II NOTYPE IMPROVEMENT SHEET

NO. 312

SECOND ELEVATOR BAR PLATE GUIDE

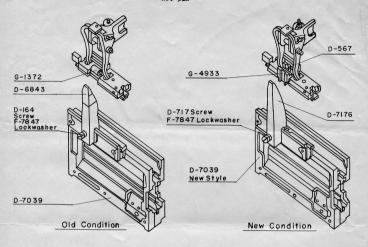
The Second Elevator Guide components have been redesigned to provide a smoother action when matrices are lifted by the Second Elevator from the Intermediate Channel. The Second Elevator Guide (Lower) (D-7176), has been redesigned and the Intermediate Channel Front Plate has a clearance cut added for a new Second Elevator Bar Plate Guide (U-1933).

The new Ear Plate Guide (G-h933) in conjunction with the Second Elevator Guide Lower (D-7176), operates to hold the matrices in a vertical position until they are clear of the Intermediate Channel.
